## National Fire Protection Association

### MEMORANDUM

**TO:** NFPA Technical Committee on Ambulances  
**FROM:** Stacey Van Zandt  
**DATE:** November 4, 2011  
**SUBJECT:** NFPA 1917 ROC TC Letter Ballot (A2012)

Recommendation: Replace existing figures A.7.9.13(a) and A.7.9.13(b) with the following:

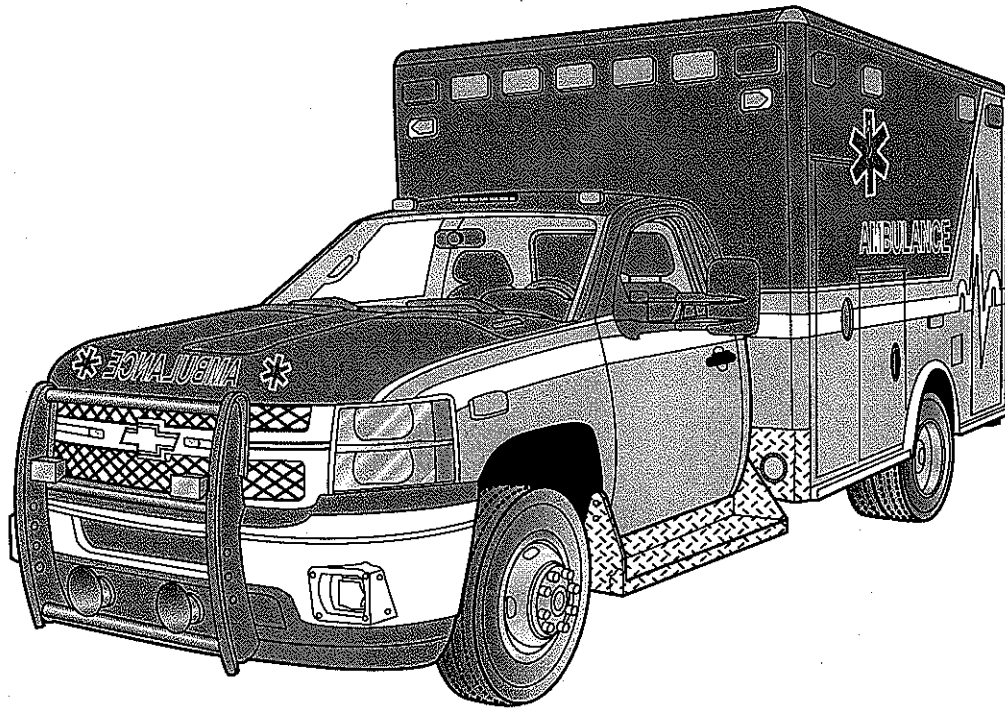
**Substantiation:** During the ROP the committee accepted proposal 1917-1153 (Log #161) to delete the figure of a fire truck and replace with a figure of an ambulance. The submitter did not supply a replacement figure. The figure of this ambulance placed in this committee comment replaces the figure of the fire truck.
